# SPECTRO1-Scope: Changes due to software update from SPECTRO1-Scope V2.2 to V2.3

This manual summarises the changes that were made with the software update from **SPECTRO1 V2.2 to V2.3**.

## Change 2:

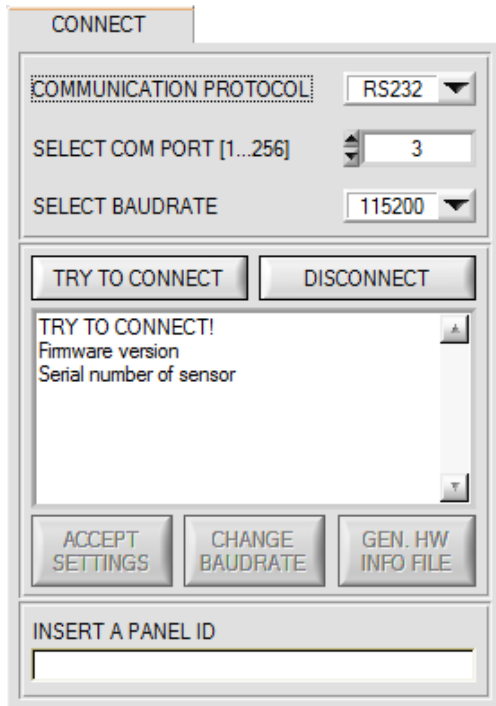
1. When a connection is established the serial number of the contacted sensor is transferred in addition to the firmware version.
2. The baudrates have been extended with 230400 and 460800.
3. **DISCONNECT** disconnects the connection between sensor and PC. The software then switches to OFFLINE mode, where it is only possible to exchange parameters with a file on a storage medium. The interface is then free for other programs (e.g. FirmwareLoader).

## Change 4:

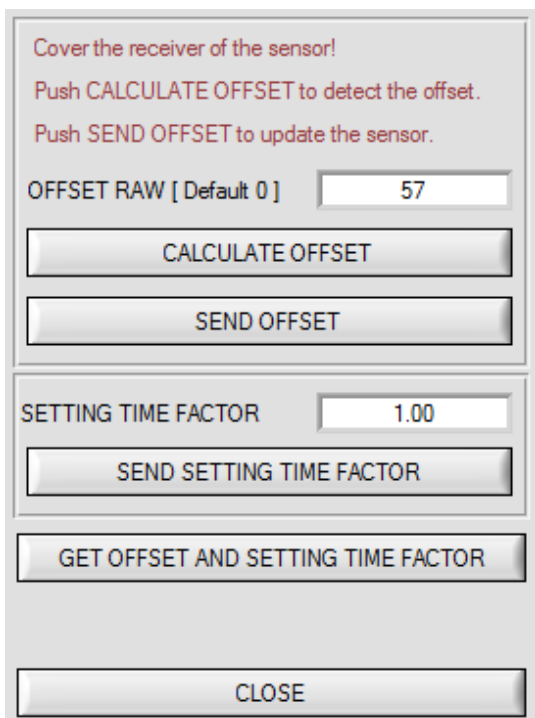
Accessing offset calibration now requires a double-click with the right mouse button in the **PARA** tab exactly on the frame under INTEGRAL in.

You will then be prompted for a password.  
The password is: mellon

This tab is now more clearly structured, but there are no other changes here.
